PRODUCT CHANGE NOTICE FORM

PCN NO. 0012
DATE: 14 July 2016

CUSTOMER P/N: DS1600SPE-3 & -001

POWER SUPPLY WATTAGE: 1600W

Schematic of SDA/SCL lines inside PSU:

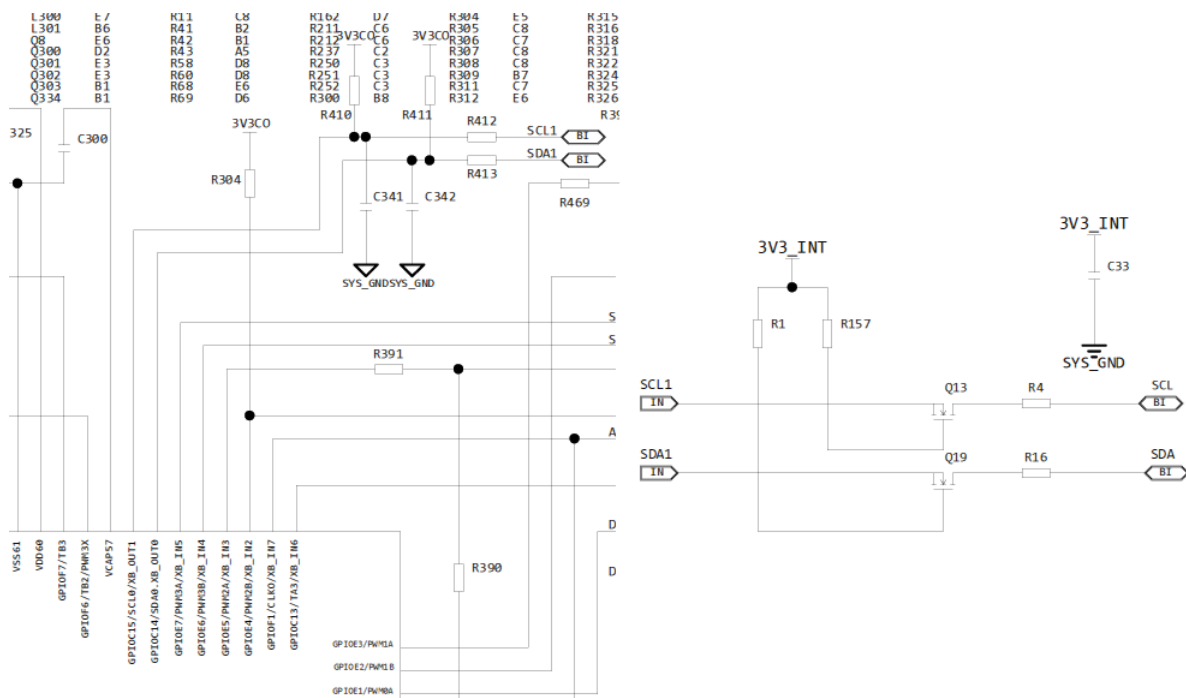
DESCRIPTION OF REQUEST	JUSTIFICATION
<ul style="list-style-type: none"> Change control board resistors R410, R411 to 8.45kΩ (IPN: 301-011706-8451). Main Board resistors R4, R16 to 49.9Ω (301-011707-49R9). Update secondary firmware i2c glitch filter. (IPN: 630-002422-0013, FW v04.10.00) Update Installation and Operating Instruction. (IPN: 970-010755-0001) 	<ul style="list-style-type: none"> Improve I2C communication noise rejection, error rate especially at SDA/SCL rise times >650ns Update Operating Instruction, change rating (from 100-140Vac to 100-127Vac) and update into new OI format

When the PSU was tested with an effective rise-time of 1usec, the I2C communication was not always successful. When the pull-up was changed to reduce the rise-time down to about 650nsec, the error rates were reduced.

- Internal SDA/SCL pull-up R410 and R411 to 8.45k Ω
- Secondary firmware with modified digital glitch filters (from 4 to 12 cycles).

- Waveform comparison using 8.45k internal pull-up:

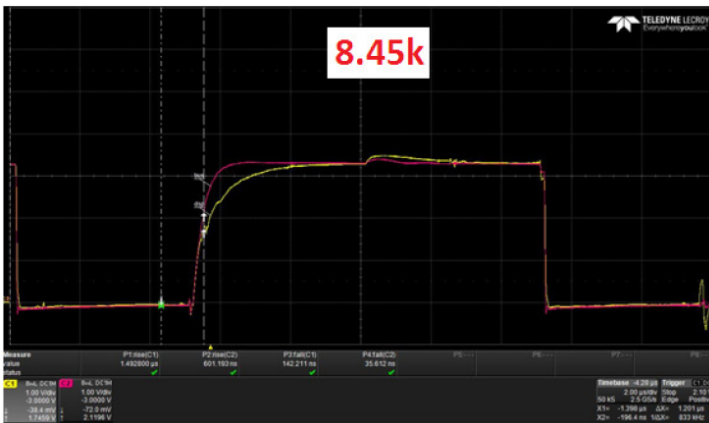
A. *Optimizing internal pull-up value: R410 and R411 to 8.45kohm*

Ch1 (yellow) = DSP pin, SDA
Ch2 (red) = Load side, SDA

Rise time (0.65V~2.25V)	8.45kΩ change
	Error Rate
950ns	1002/10777 = 9.29%
750ns	58/10706 = 0.542%
650ns	0/10308 = 0.0%
550ns	0/10501 = 0.0%
